No. 167

June 25, 2003

TECHNICAL BULLETIN

## AD-115 LINT DRAWER CHANGE

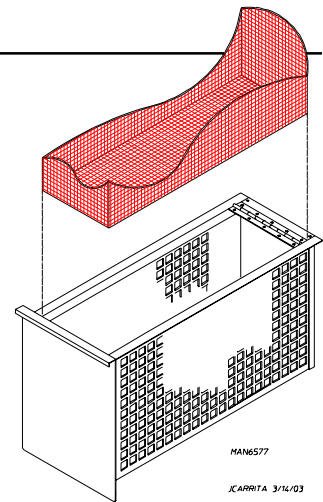
As of **March 25, 2003**, the lint drawer assembly on the model AD-115 has changed, where now a removable lint BAG is used. As the result of this change, the lint drawer differs. This new assembly is totally interchangeable with units existing in the field, which were manufactured without a drop in lint BAG.

### CURRENT PRODUCTION DRAWER W/BAG

ADC P/N	DESCRIPTION
850948*	LINT DRAWER WITH LINT BAG
820017	LINT BAG

### PREVIOUS TYPE DRAWER

ADC P/N	DESCRIPTION
803023*	LINT DRAWER

## AD-120 LINT DRAWER CHANGE

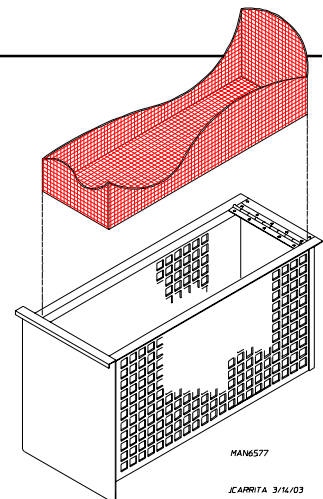
As of **March 25, 2003**, the lint drawer assembly on the model AD-120 has changed, where now a removable lint BAG is used. As the result of this change, the lint drawer differs. This new assembly is totally interchangeable with units existing in the field, which were manufactured without a drop in lint BAG.

### CURRENT PRODUCTION DRAWER W/BAG

ADC P/N	DESCRIPTION
850950*	LINT DRAWER WITH LINT BAG
820017	LINT BAG

### PREVIOUS TYPE DRAWER

ADC P/N	DESCRIPTION
802106*	LINT DRAWER

## ADS-410 FAN PULLEY/BELT CHANGE

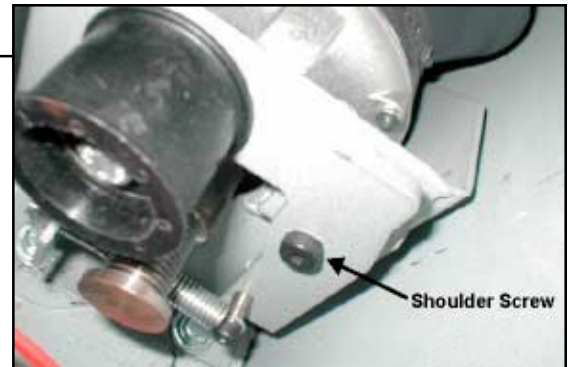
As of **April 3, 2003**, the fan pulley and belt on the AD-410 (steam) has changed. The pulley was changed from a 2B 6.8 (ADC P/N 101175) to a 2B 5.2 (ADC P/N 101202) pulley. In addition, the V-belt has changed from a BX-70 (ADC P/N 100125) to a BX-67 (ADC P/N 100188) belt.

## S.A.F.E. WATER CONNECTION

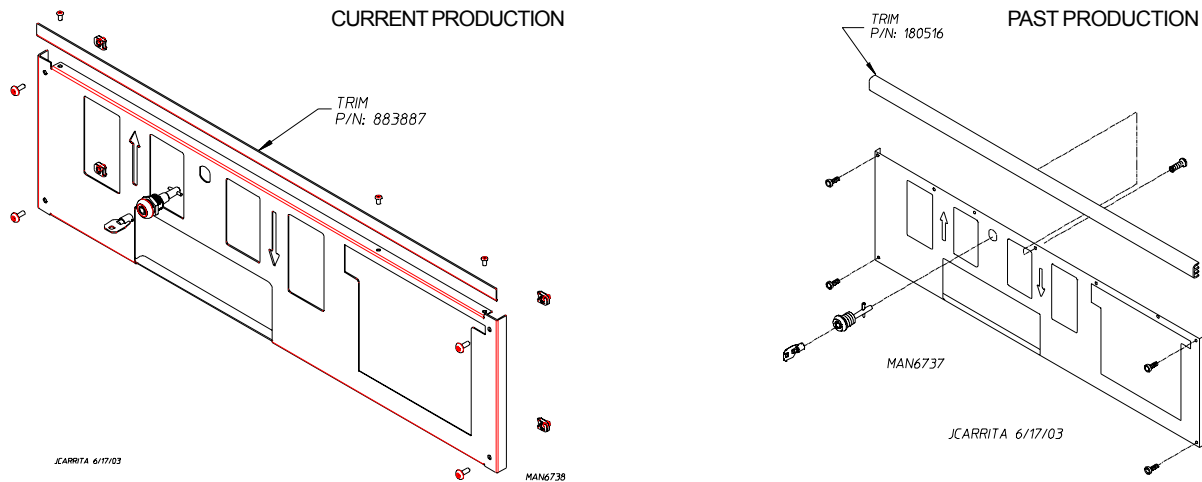
As of **June 13, 2003**, a wired tag with important information is affixed to the water connection of each S.A.F.E. dryer. This tag is a reminder to the installer to provide the correct water supply requirements.

**WATER SUPPLY PRESSURE MUST BE 40 PSI +/- 20 PSI  
(2.75 bar +/- 1.37 bar) FOR S.A.F.E./F.S.S.  
SYSTEM TO OPERATE PROPERLY.**
